Re: Turkey Point Units 3 and 4  
Docket Nos. 50-250 and 50-251  
St. Lucie Units 1 and 2  
Docket Nos. 50-335 and 50-389  
Topical Quality Assurance Report (FPLTQAR 1-76A)

**Florida Power & Light  
Topical Quality Assurance Report  
Change Summary  
June 2000  
(Page 1 of 6)**

Summary of changes to the Florida Power & Light Topical Quality Assurance Report (FPL TQAR 1-76A) since June 1999.

TOPICAL QUALITY ASSURANCE REPORT	REVISION 33 DRAFT A (R1014)
ORGANIZATION OF DEPARTMENTS AFFECTING QUALITY FIGURE 1-1 APPENDIX A NUCLEAR DIVISION	11/01/99
	PAGE 1 OF 2

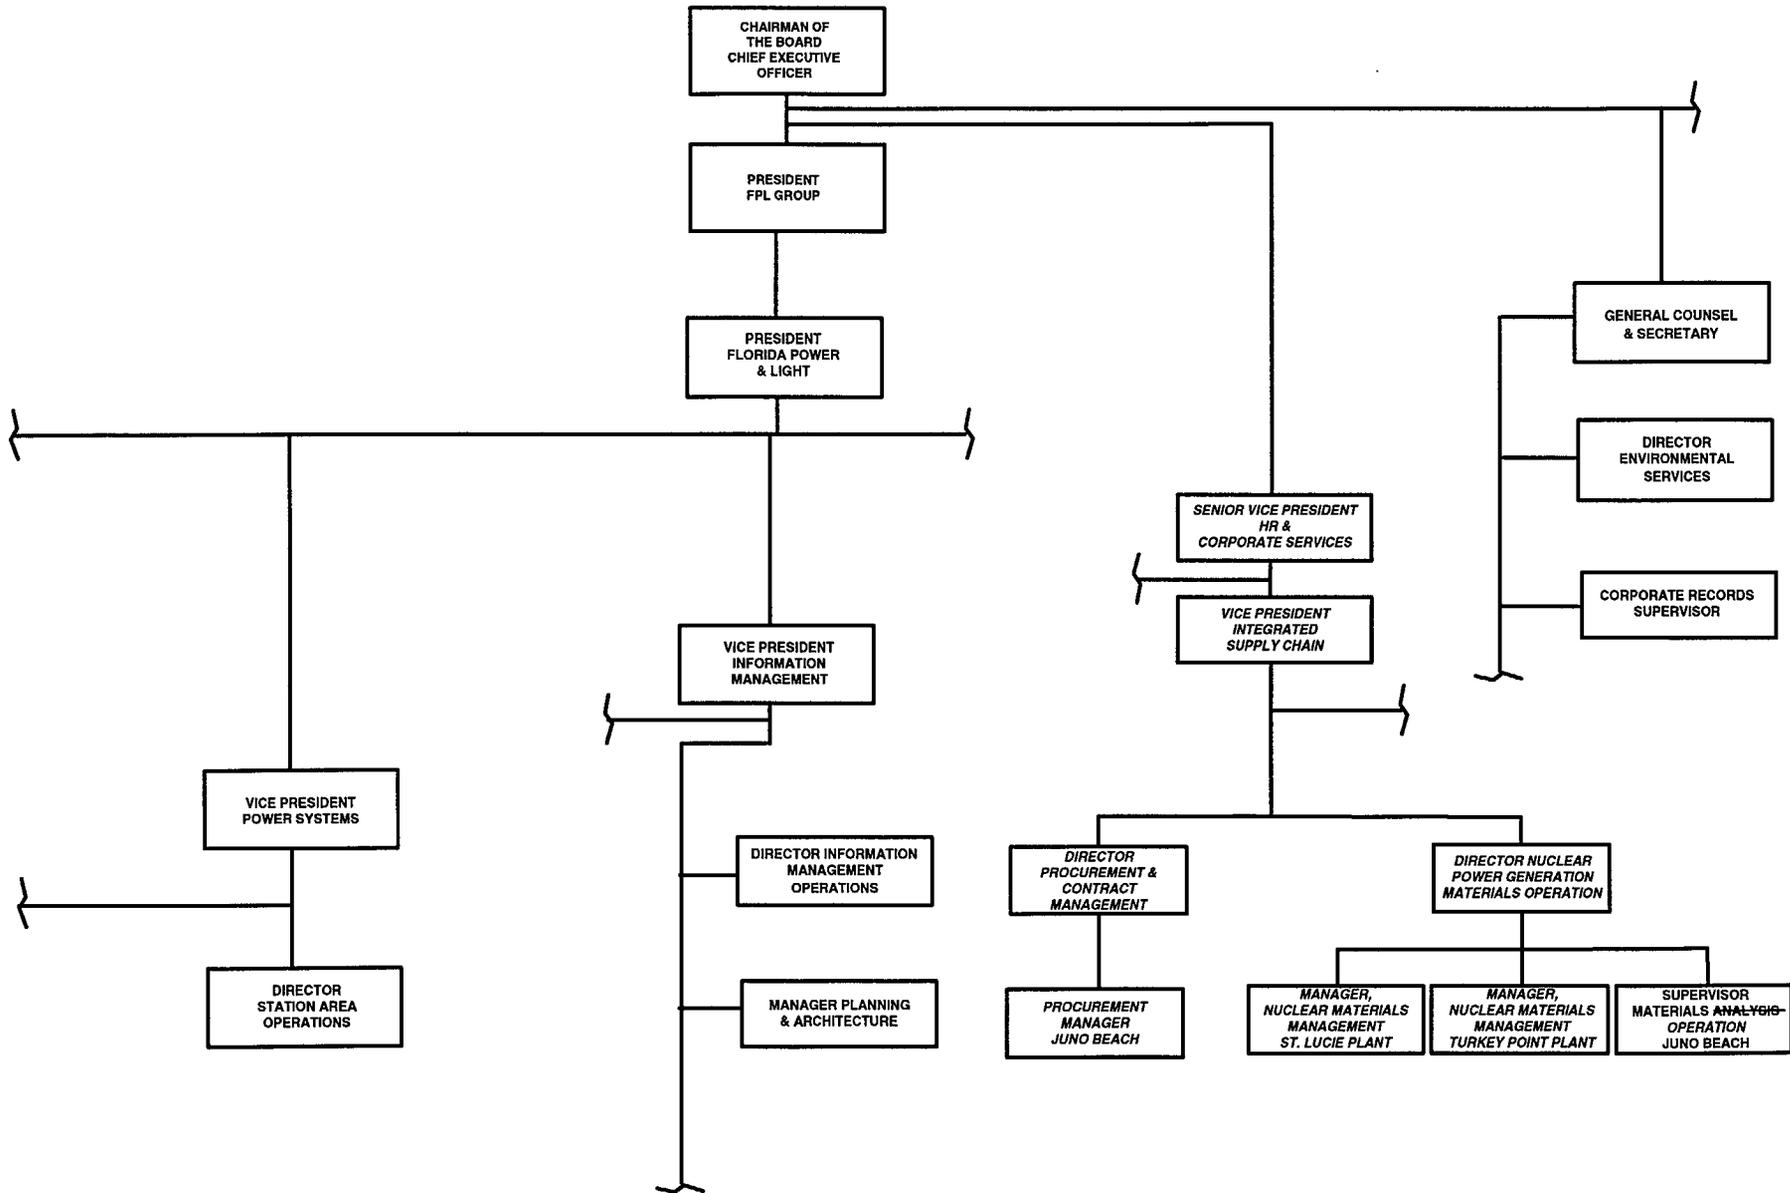
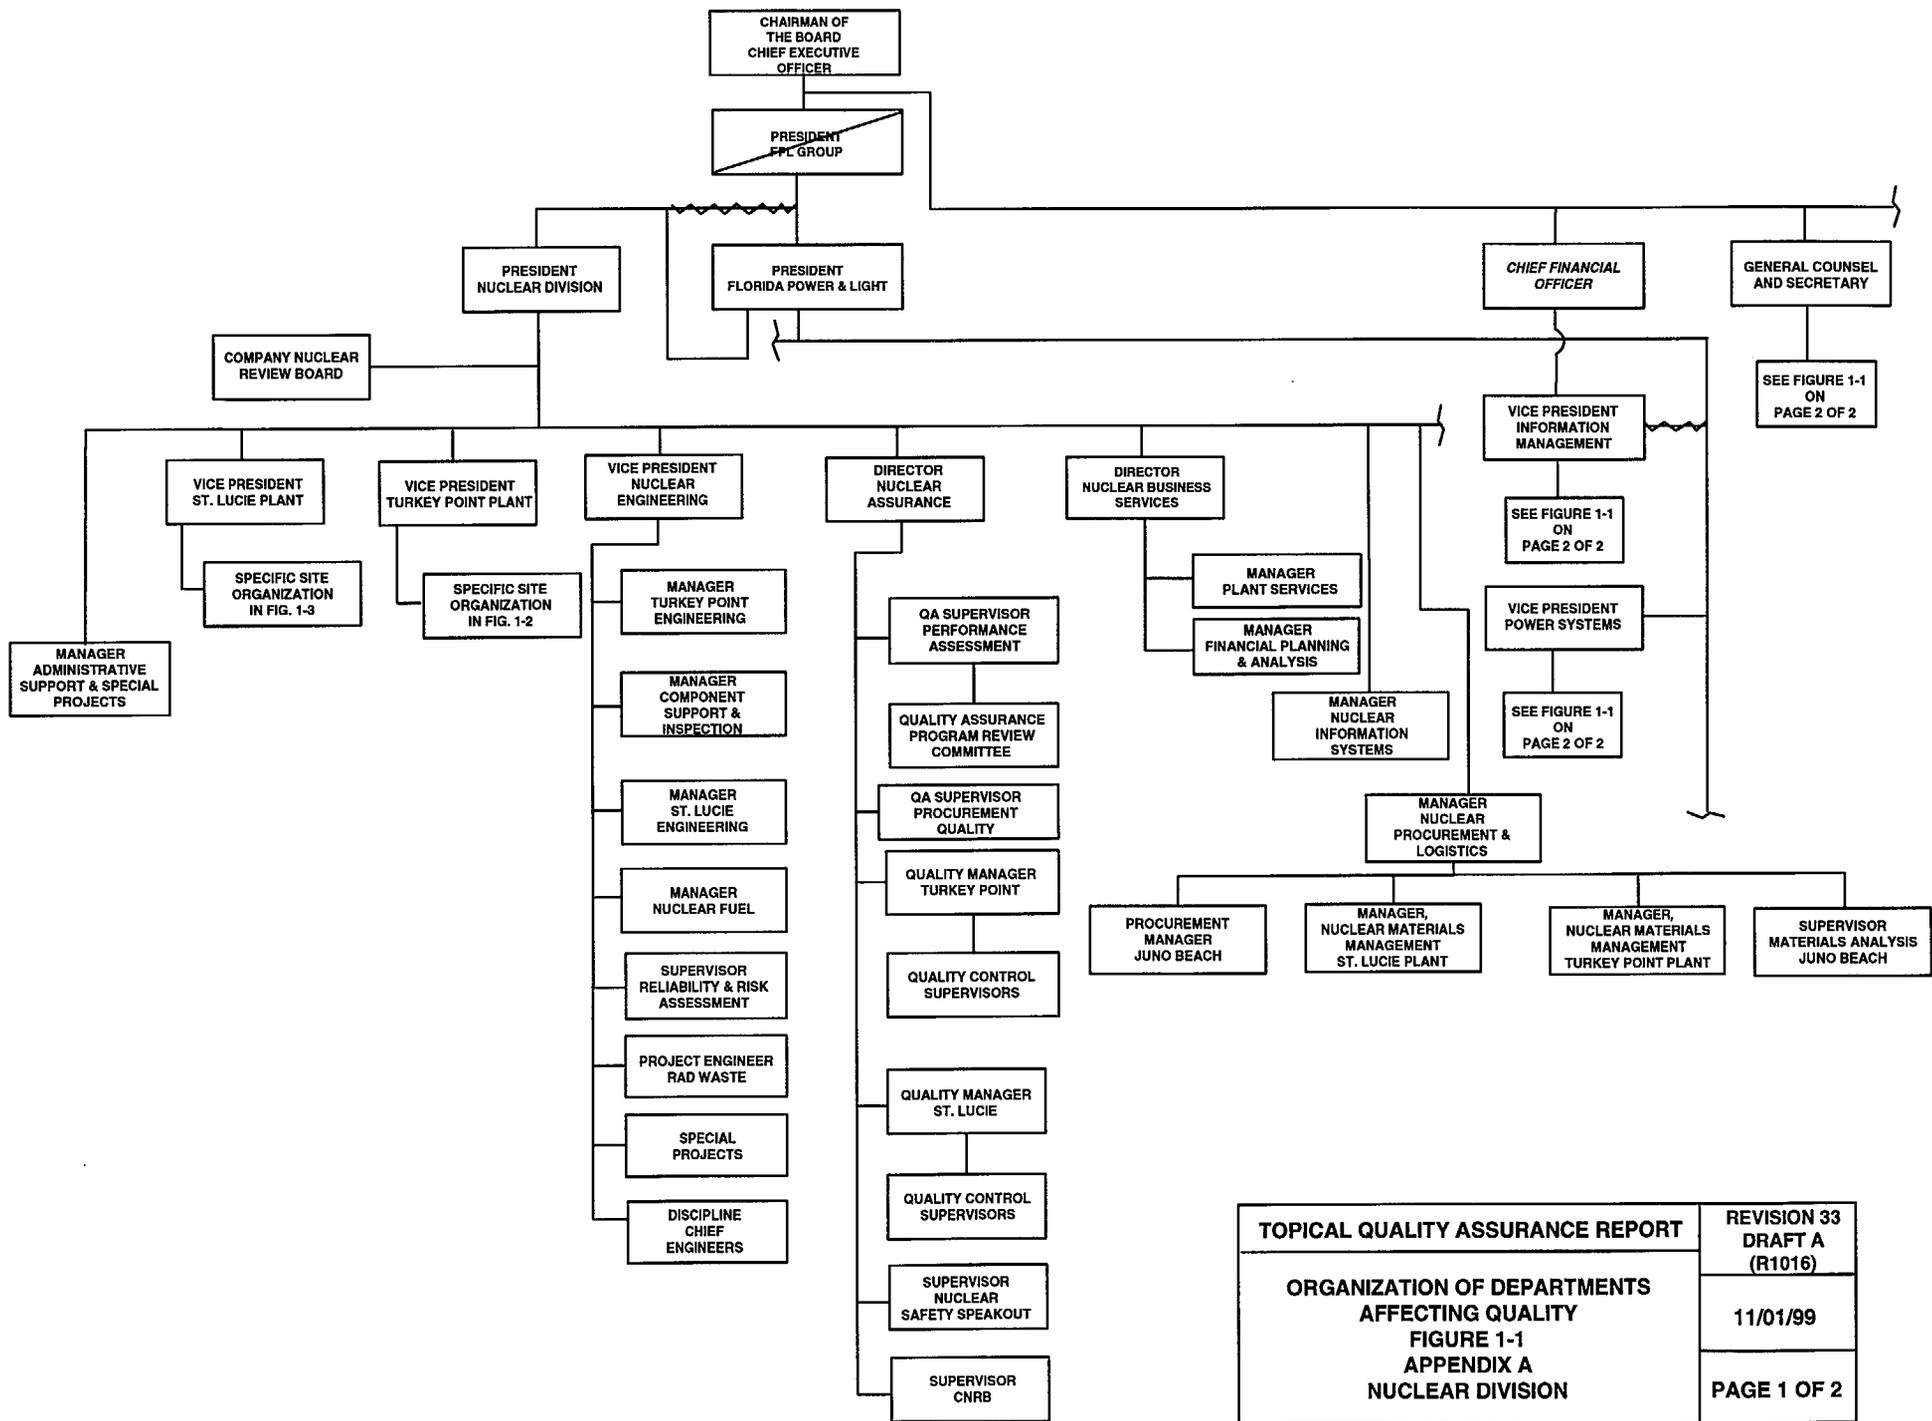
28. APPENDIX A, FIGURE 1-1: ORGANIZATION & FIGURES (Rev. 32 to Rev. 33)

Revise the organization for Integrated Supply Chain.

TOPICAL QUALITY ASSURANCE REPORT	REVISION 17 (R1026)
TURKEY POINT PLANT SITE ORGANIZATION FIGURE 1-2 APPENDIX A	02/02/00
	PAGE 1 OF 1

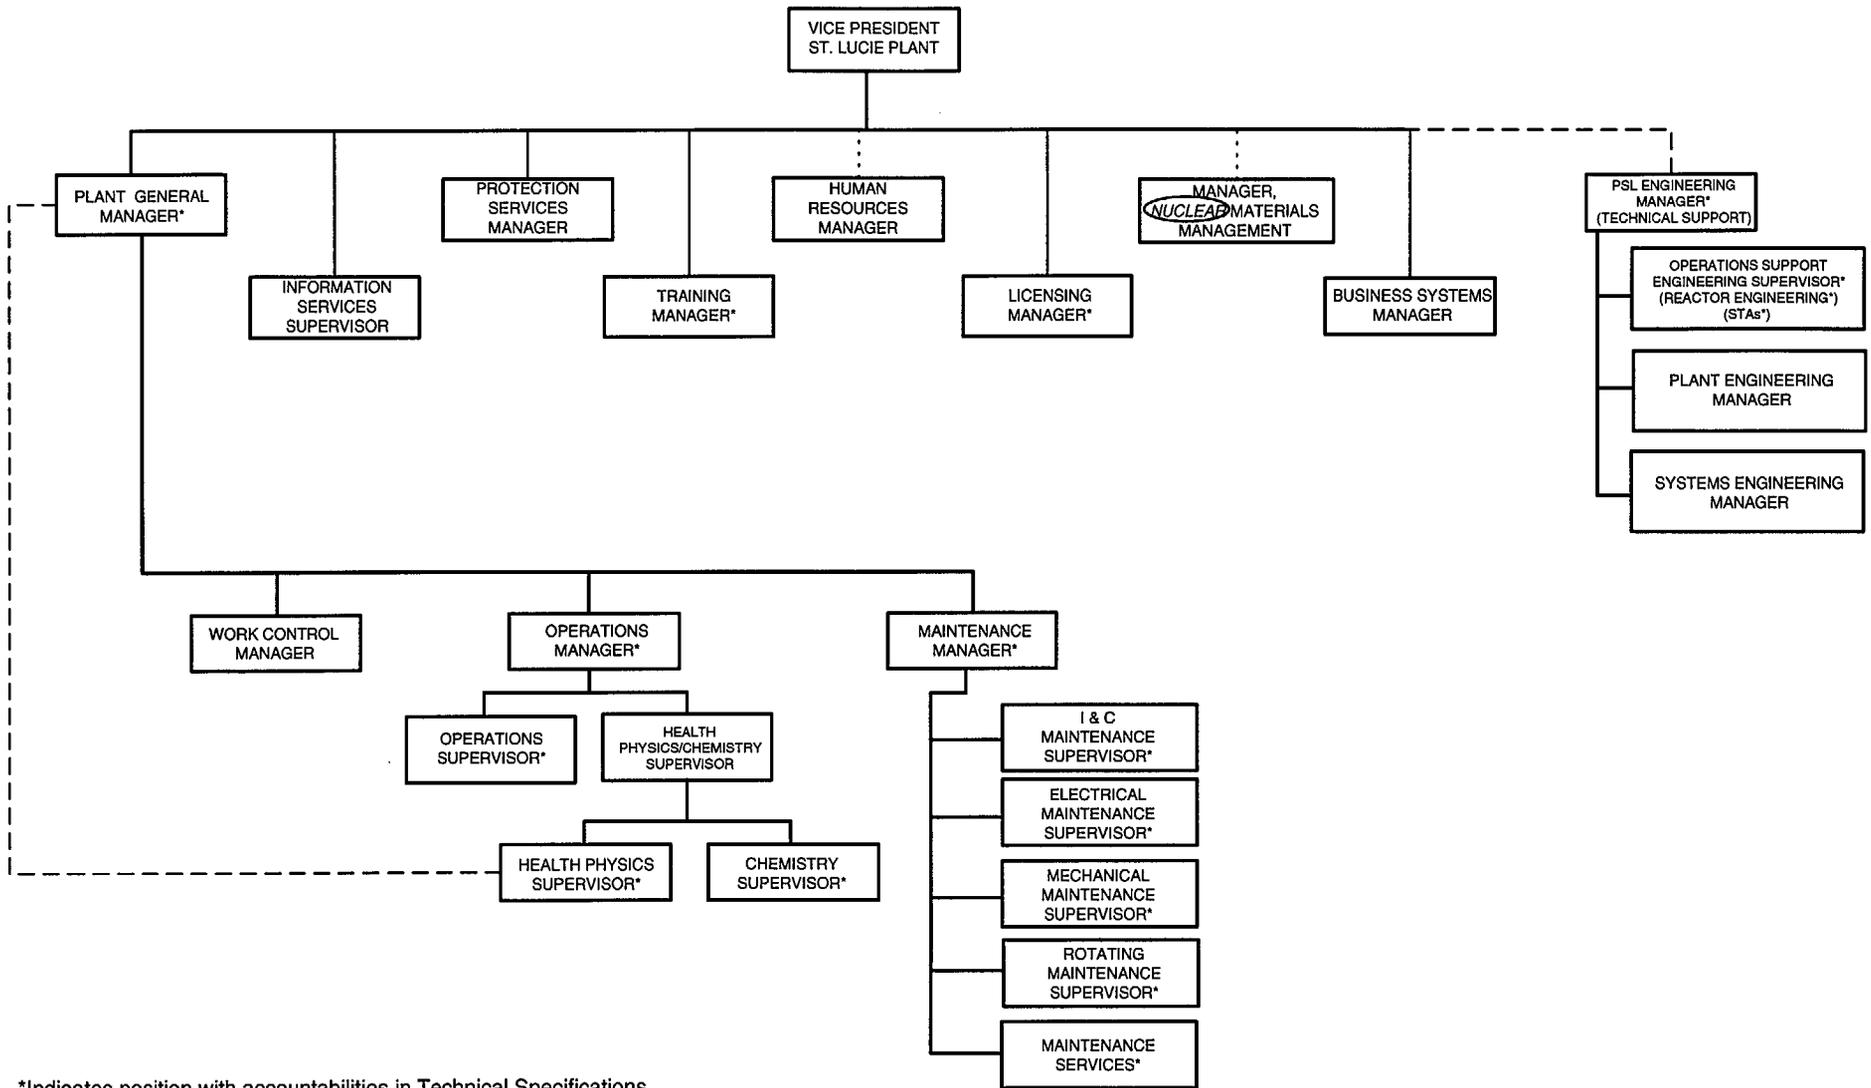
~~Although Operations Support Engineering (OSE) Reactor Engineering and STA~~ personnel may report to the Site Engineering Manager **or any group under the Site Engineering Manager**, and the Plant General Manager shall have direct and unfettered control over those activities necessary for safe operation and maintenance of the plant.
